UNITED STATES SUGAR CORPORATION

RE: Hendry County AP - Clewiston Mill Boiler No. 4
DEP File No. AO26-223258

**EVALUATION OF ALTERNATIVE CO CONTROL TECHNOLOGIES
FOR
U.S. SUGAR CORPORATION CLEWISTON BOILER NO. 4**

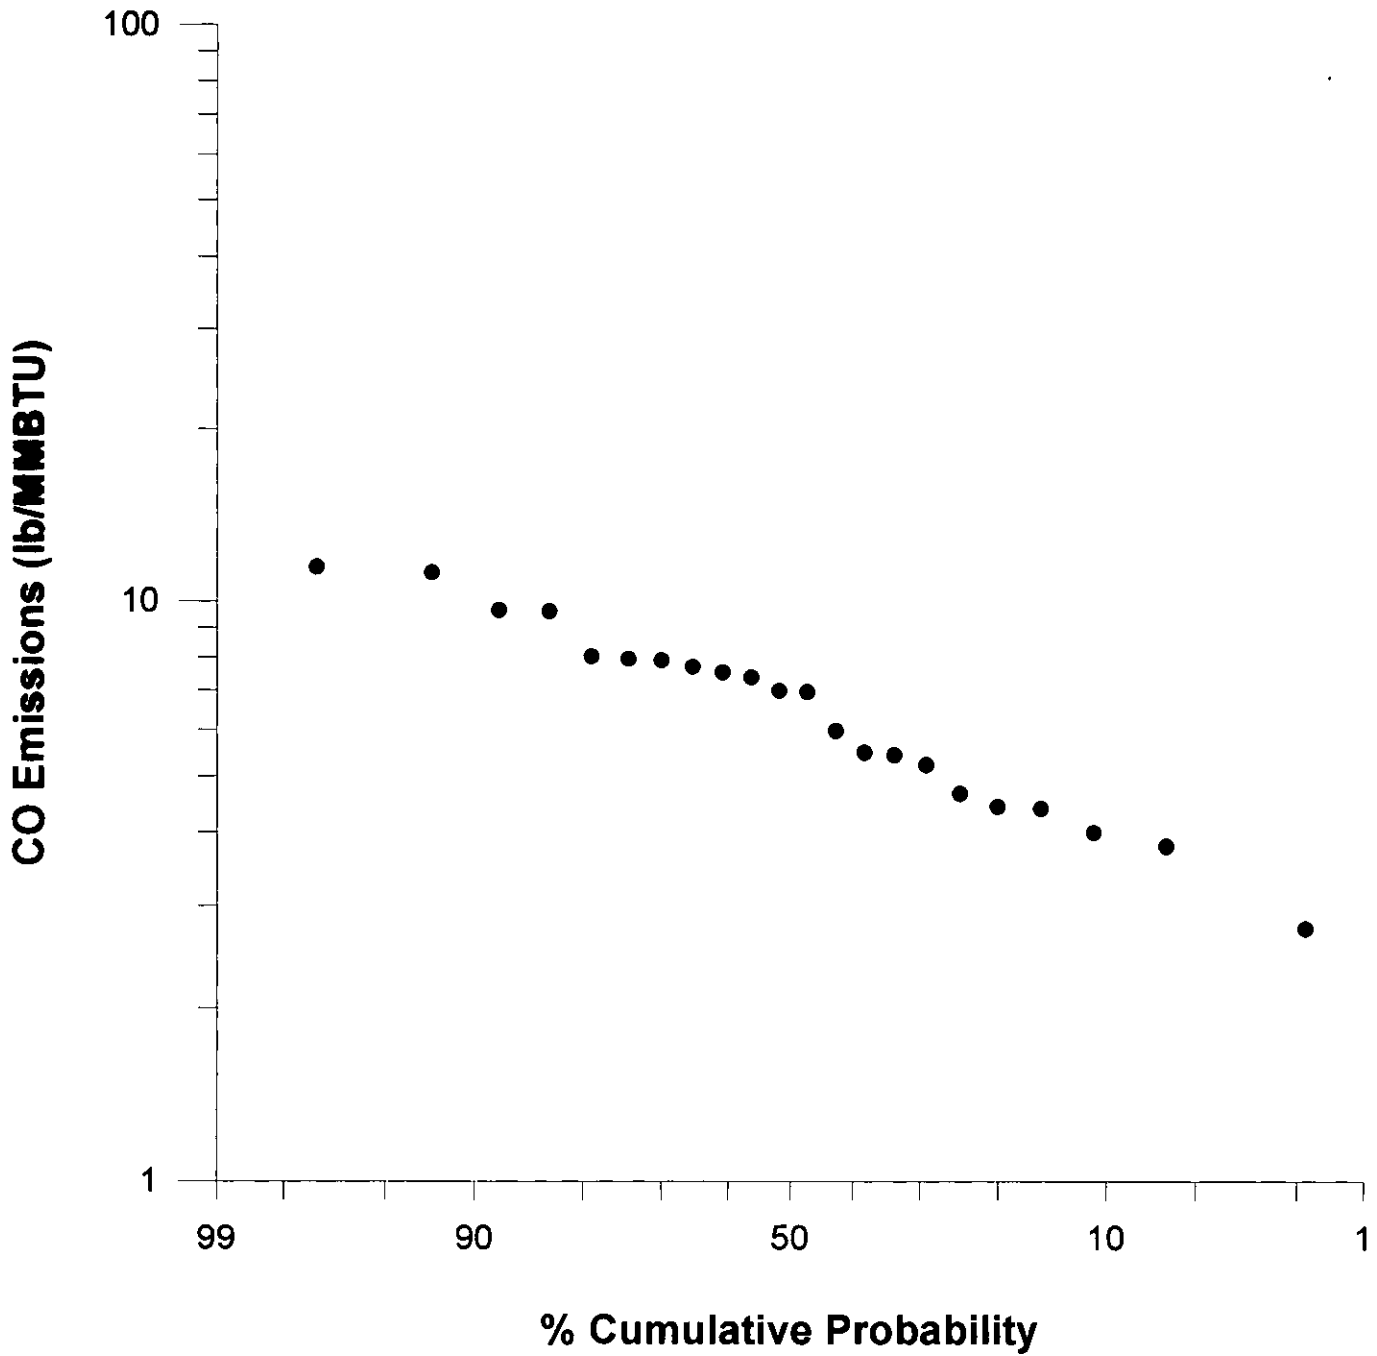
The revised CO emission limit proposed for Boiler No. 4 is 9.0 lb/MMBtu heat input and is based on a maximum CO emission rate developed from statistical analysis of actual test data using EPA Method 10. These data are presented in Table 1, and are also presented graphically in a frequency distribution plot in Figure 1. The proposed maximum emission rate is based on a
